Re: Proposed Site Assessment Plan
South Eunice Seven Rivers Queen Unit #426

Lea County, New Mexico

Ensolum, LLC (Ensolum), on behalf of Hilcorp Energy Company (Hilcorp), has prepared the following *Proposed Site Assessment Plan* (Assessment Plan) for the South Eunice Seven Rivers Queen Unit #426 well pad (Site) in association with the Apache-Hilcorp South Eunice Seven Rivers Queen Unit Transfer. A *Proposed Site Reclamation Plan* was submitted to the New Mexico State Land Office (NMSLO) for this Site on September 2, 2025. The NMSLO denied the *Proposed Site Reclamation Plan* on September 23, 2025 for the following reasons:

### **Proposed Soil Sampling Locations**

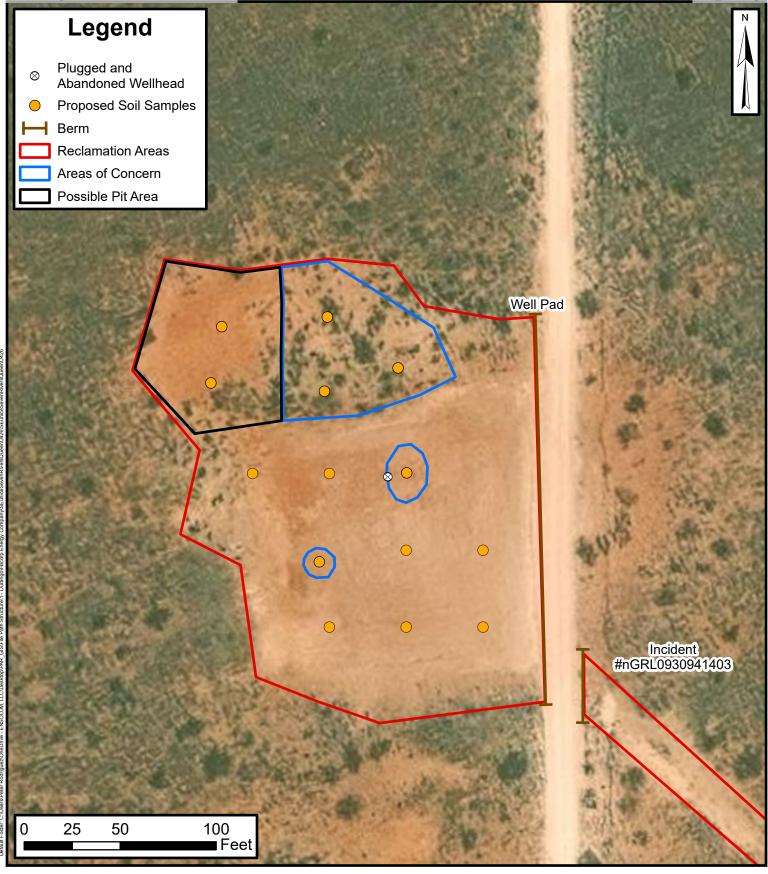
- Site assessment/delineation For well pad areas of concern: due to sandy soil all assessment samples must extend to a minimum of 2 ft bgs. 1 ft bgs is not sufficient for sandy soils and for a location that has had extensive earthwork already.

- Potential impacts to soil were identified on the well pad during a review of historical satellite imagery and salt crusting was observed in the revegetated area north of the well pad during the Site visit. The areas of concern and proposed sampling locations are presented on Figure 3.

- In order to evaluate for the presence or absence of impacted soil, Hilcorp proposes to collect discrete assessment soil samples from a depth of 2-feet bgs, or right above bedrock if encountered, in the areas of concern. The soil samples will be field screened for volatile organic compounds (VOCs) utilizing a calibrated photoionization detector (PID) and chloride using Hach<sup>®</sup> chloride QuanTab<sup>®</sup> test strips.

- Since the release location of Incident Number nLWJ1011834641 is unknown, Hilcorp proposes to collect discrete samples for every 3,000 square feet of the well pad. Soil samples will be

collected at a depth of 2-feet bgs, or right above bedrock refusal if shallower than 2 feet bgs. The soil will be field screened using the above described procedures. The proposed sampling locations are presented on Figure 3.
